POLICY REPORT  
DEVELOPMENT AND BUILDING

TO: Vancouver City Council  
FROM: Acting General Manager of Planning and Development Services  
SUBJECT: CD-1 Rezoning: 6318-6340 Cambie Street

6318-6340 Cambie Street  
DRAFT CONDITIONS OF APPROVALS

Site Plan/Landscape Plan

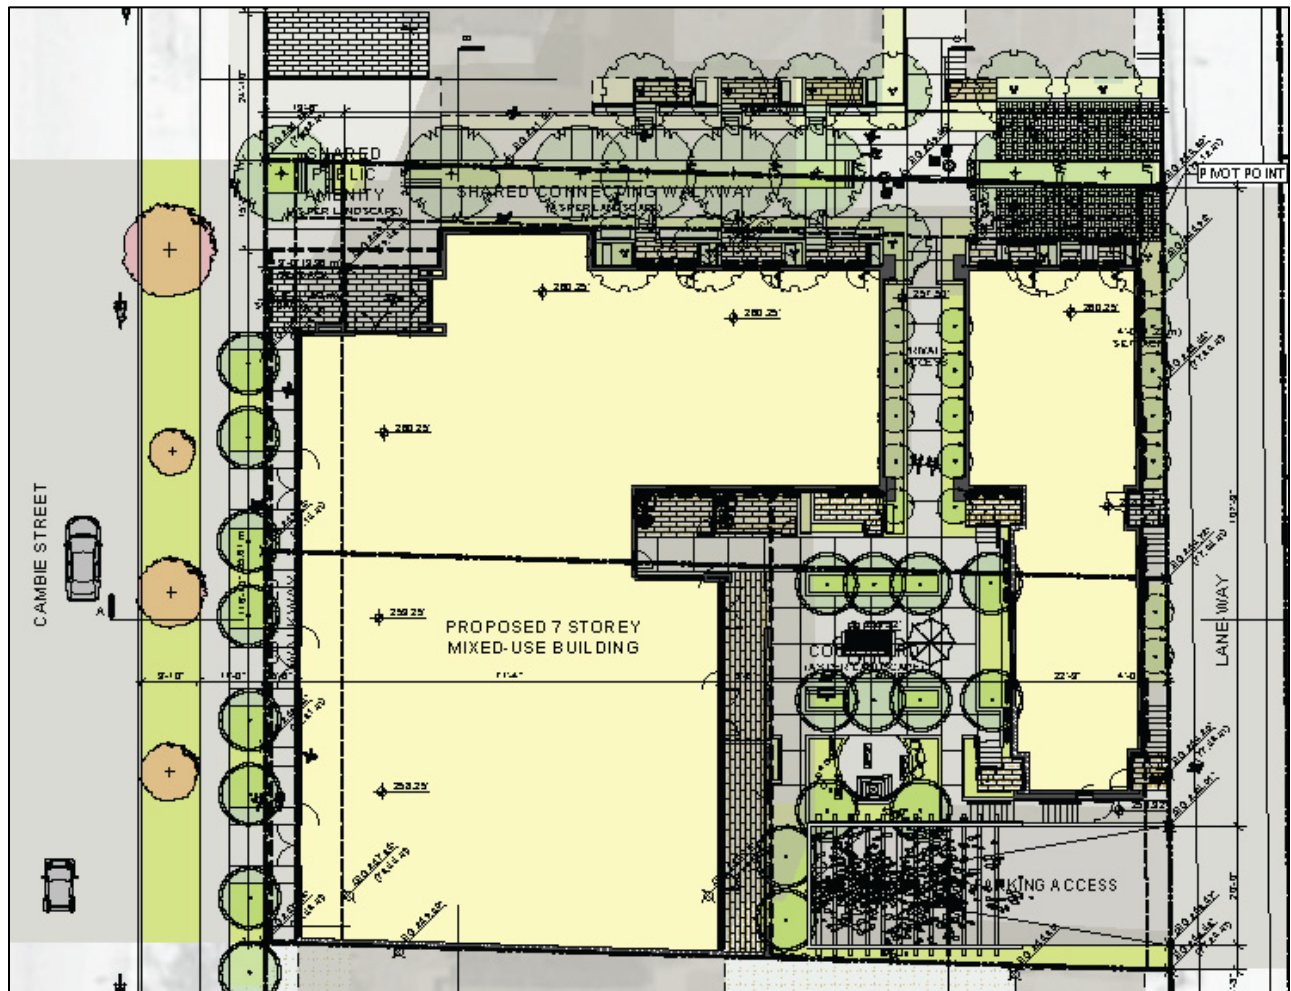
The larger building adds an intense verticality and canyon-like quality to the area, and the transition between the six-storey and two-storey forms seems too harsh. While the six-storey form is well articulated and could be set-back in order to off-set this effect, consideration in the future should be given to allowing three storeys or creating more verticality in the townhouses in order to facilitate the transition.

The rooftop cover is not supportable as it looks like an additional storey. While it is important that it be usable by residents of the building, it cannot look like another floor to the development.

Townhouse number four and five don't seem to be livable in that they are overhung by the building above, and the ground and second level floors seem to be oddly disconnected from the logic of the building. If the amenity space was moved to this corner and the townhouses wrapped down and around the courtyard it would free up the massing logic and create a strong entrance to the courtyard. There also seems to be an odd living arrangement in the lane townhouses where the most private spaces seem to be on the lower level. This destroys porosity and community within the area and people do not connect through their bedroom windows.
